CITY OF TAMPA

CONTRACT ADMINISTRATION DEPARTMENT

ADDENDUM NO. 1

Contract 14-C-00056; Harbour Island Roadway Surface Replacement

SECTIONS
& DETAILS

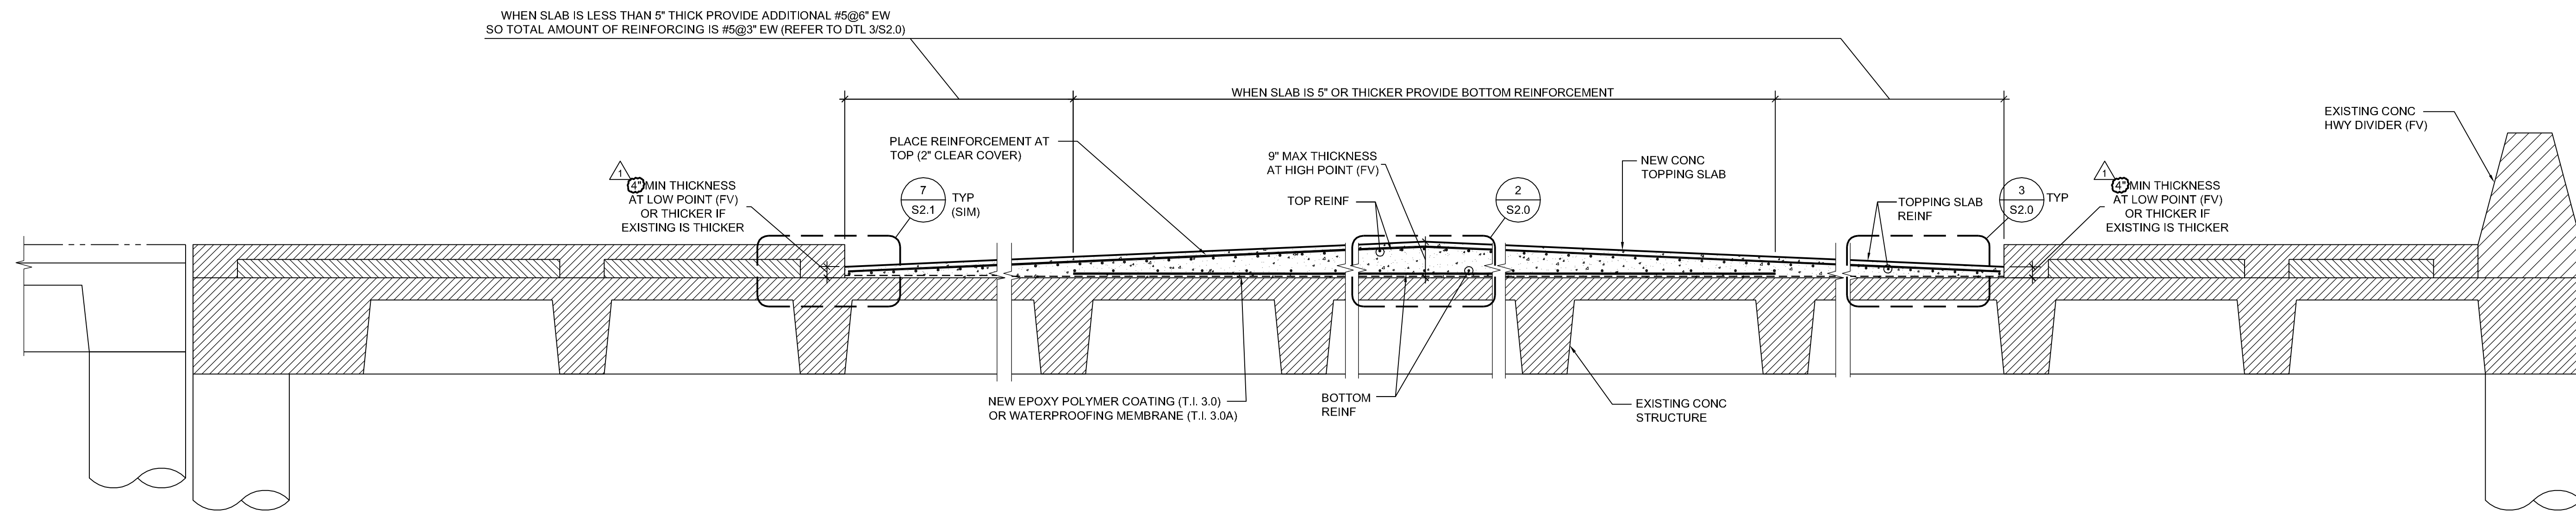
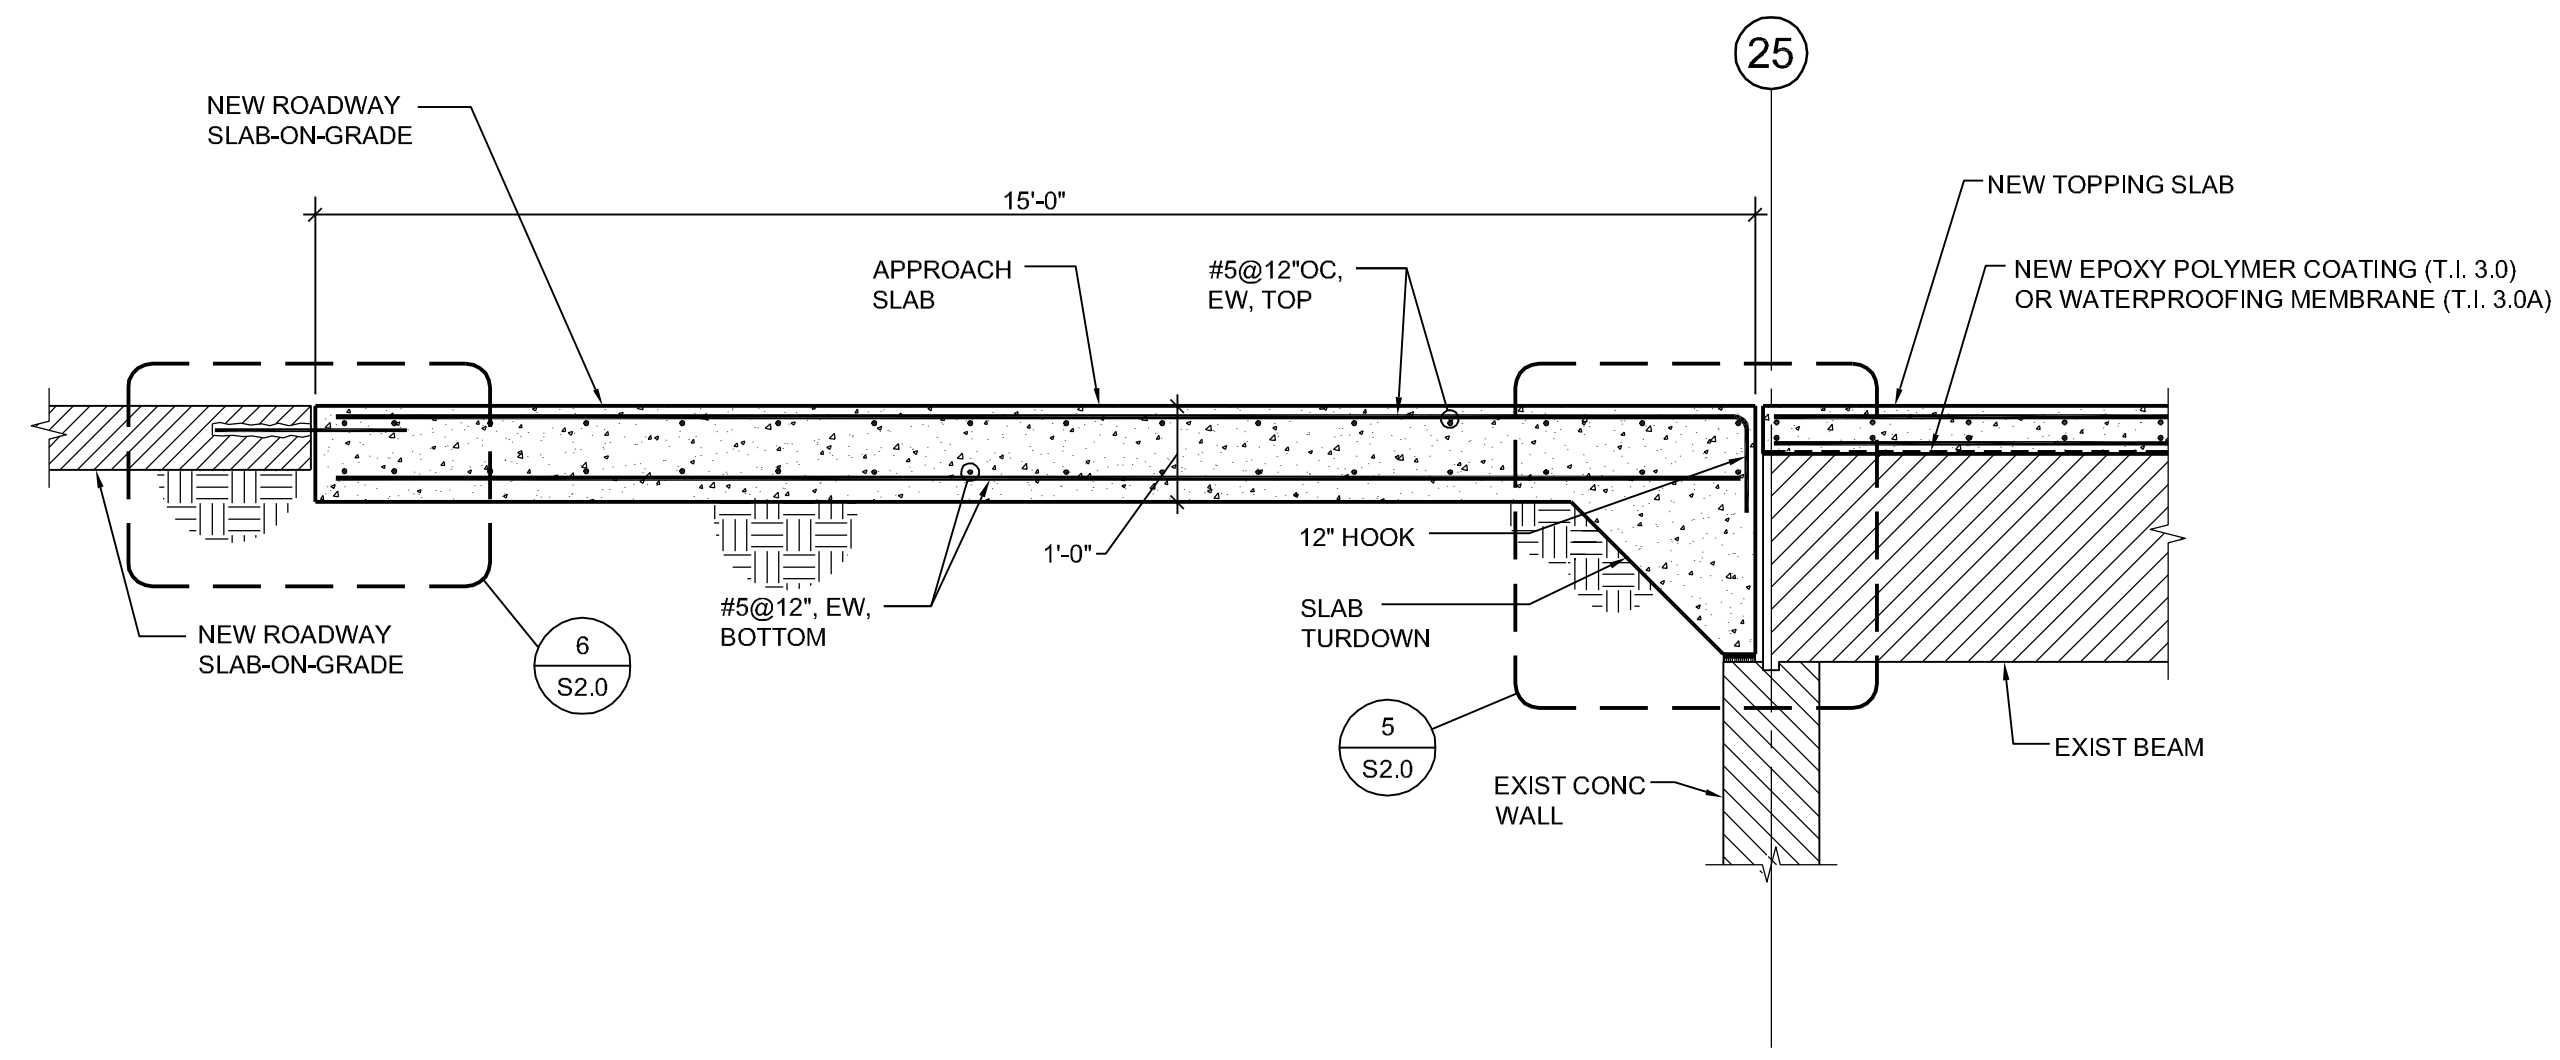
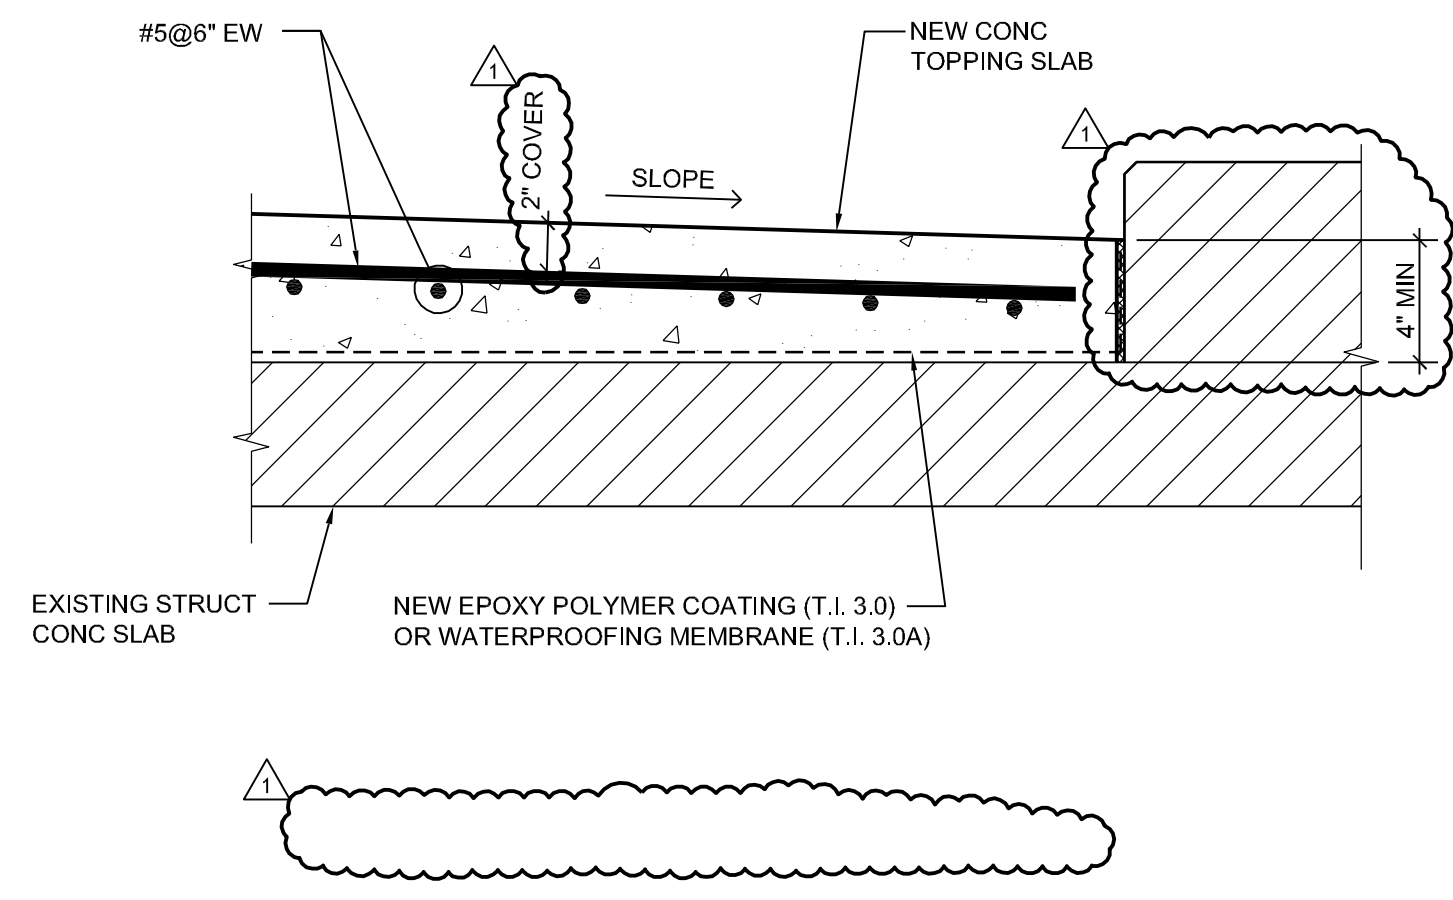
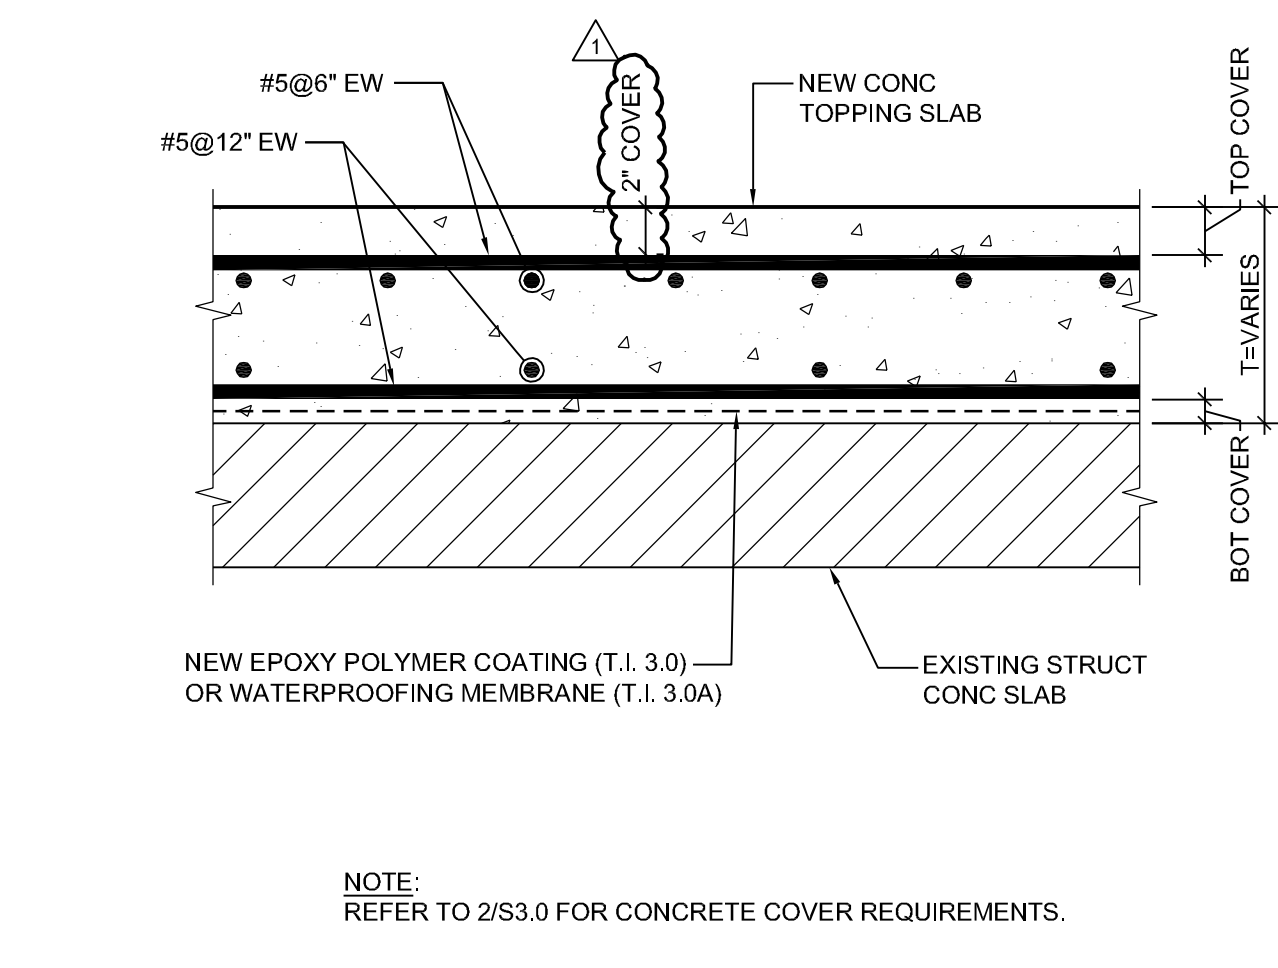
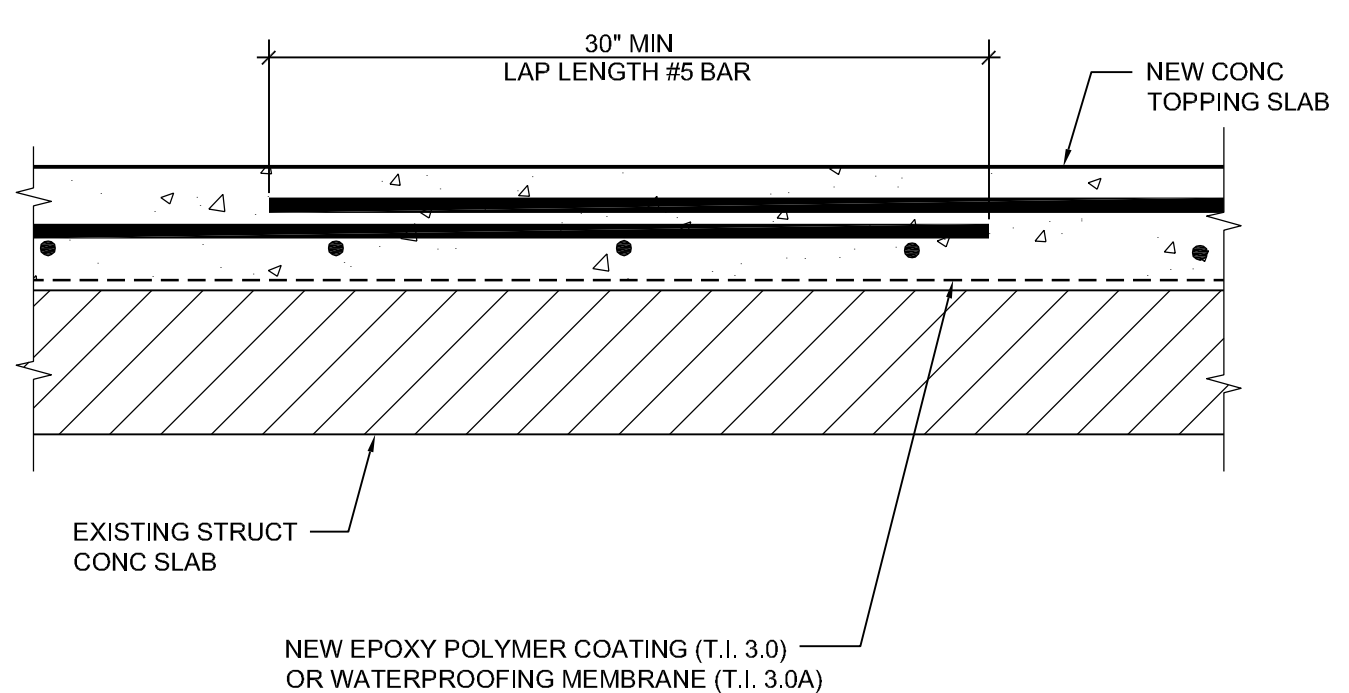
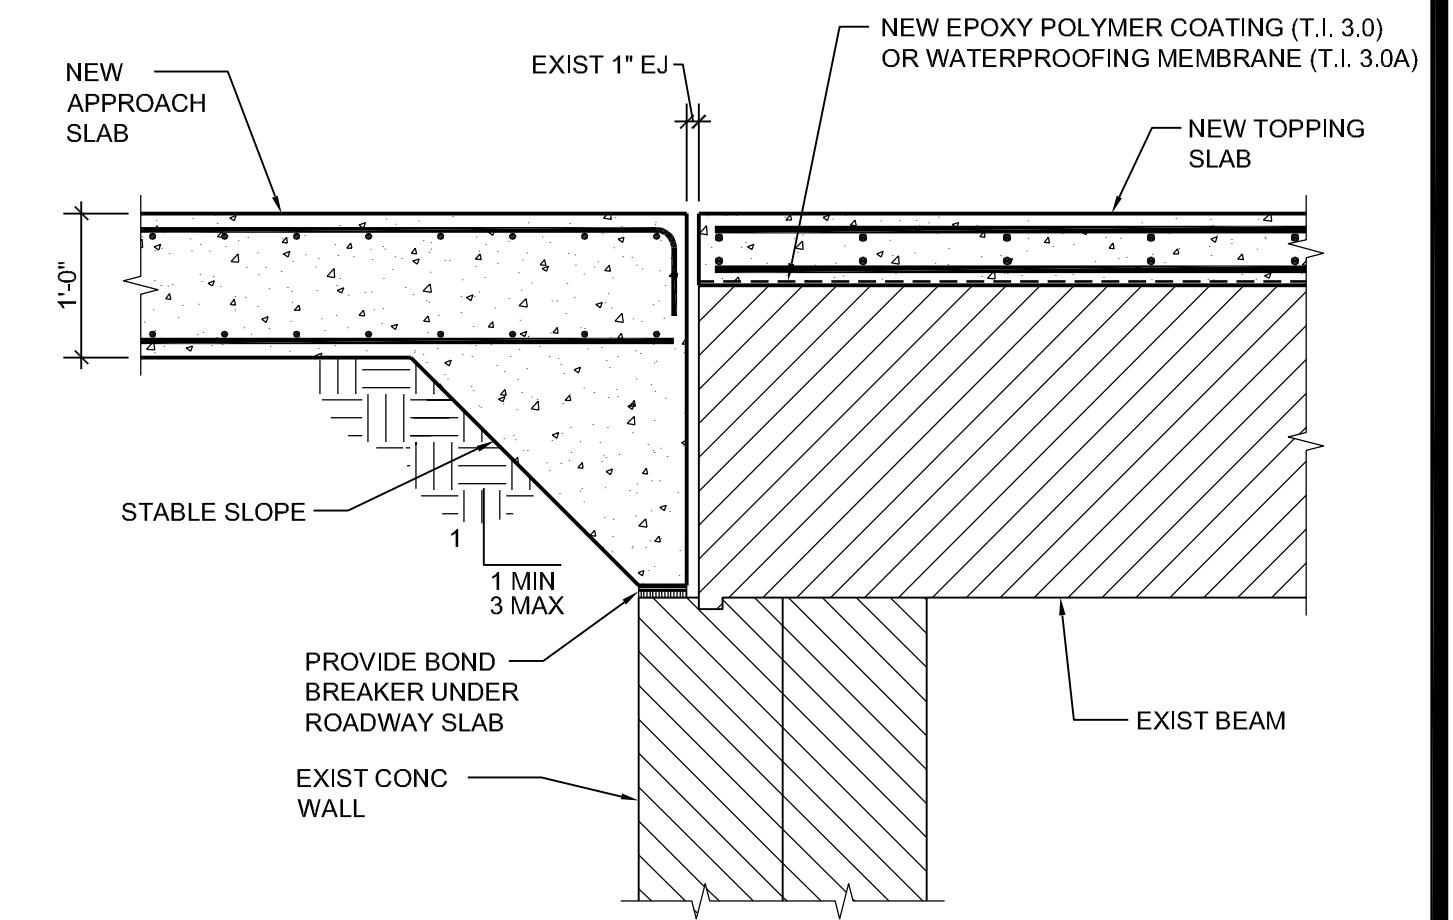
- Item 1: Replace Proposal page P-3 with the attached Proposal page P-3R
- Item 2: Section 01 10 00 Task Items, page 01 10 00 -7, T.I. 5.1 C. Execution: Delete paragraph 1.
- Item 3: Section 01 45 29 Structural Testing and Inspections, page 01 45 29 – 2, 1.5 Contractor Responsibilities: Delete paragraph A.
- Item 4: Replace Plan Sheets S1.3, S1.4, S1.5, and S2.0 with the attached, revised Plan Sheets S1.3, S1.4, S1.5, and S2.0.
- Item 5: Attached for reference is the pre-bid meeting sign-in sheet.

No.	Date	Description
Δ	08.DEC.14	ADDENDUM 1
